# Access Compliance Report

## Public Rights-of-Way

### (Curb Ramps)

Intersection ID: 27871	Main Street: HARRISON'S CROSSING_AV	Cross Street: STRICKLAND_CT	Location: E
ADA ID: 03B23D0D72B1	Ramp Type: Perp	Initial Pass/Fail: Fail	Overall Compliance: No
Severity Score: 26.25			
Codes/Mitigation Info/Possible Solution		Field Measurements/Component Compliance

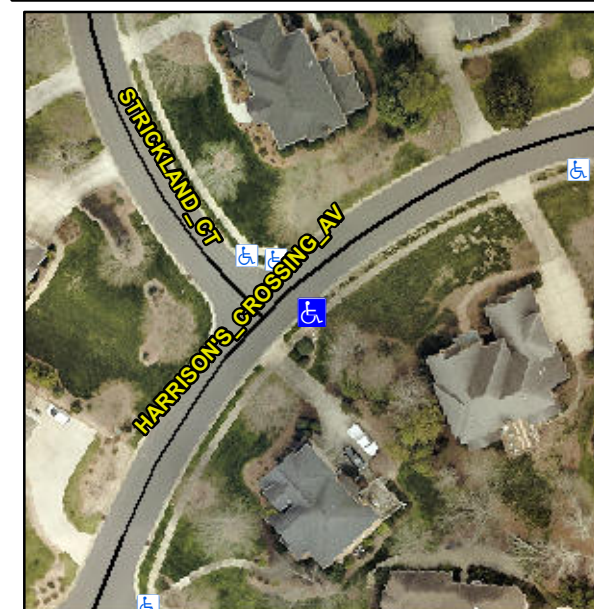
**Not Found, R304.2.2, R304.5.3**

Compliance	Description	Data	Compliance	Description	Data
N/A	Ramp Length (in)	36.0	No	Ramp Slope (%)	14.1
Yes	Ramp Width (in)	48.0	No	Ramp XSlope (%)	4.3
N/A	Flare Type LT	N/A	N/A	Flare Type RT	N/A
N/A	Flare Slope LT (%)	N/A	N/A	Flare Slope RT (%)	N/A
N/A	Flare Traversable LT?	N/A	N/A	Flare Traversable RT?	N/A
N/A	Landing Length (in)	N/A	N/A	DWS Provided?	N/A
N/A	Landing Width (in)	N/A	N/A	DWS Contrast?	N/A
N/A	Landing Slope (%)	N/A	N/A	DWS Length (in)	N/A
N/A	Landing X Slope (%)	N/A	N/A	DWS Full Width?	N/A
N/A	Landing Curb? (Y/N)	N/A	N/A	DWS Offset (in)	N/A
N/A	Shared Landing?	N/A			
N/A	Gutter Ponding?	N/A	N/A	Gutter Slope (%)	N/A
N/A	Gutter Lip Ht (in)	N/A	N/A	Gutter X Slope (%)	N/A
N/A	Painted X Walk1?	No	N/A	Painted X Walk2?	N/A
	X Walk 1 Direction	To NW		X Walk 2 Direction	N/A
N/A	X Walk 1 Width (in)	N/A	N/A	X Walk 2 Width (in)	N/A
	X Walk 1 Slope (%)	3.1		X Walk 2 Slope (%)	N/A
	X Walk 1 X Slope (%)	2.3		X Walk 2 X Slope (%)	N/A

**Remove & Replace Entire Ramp.**
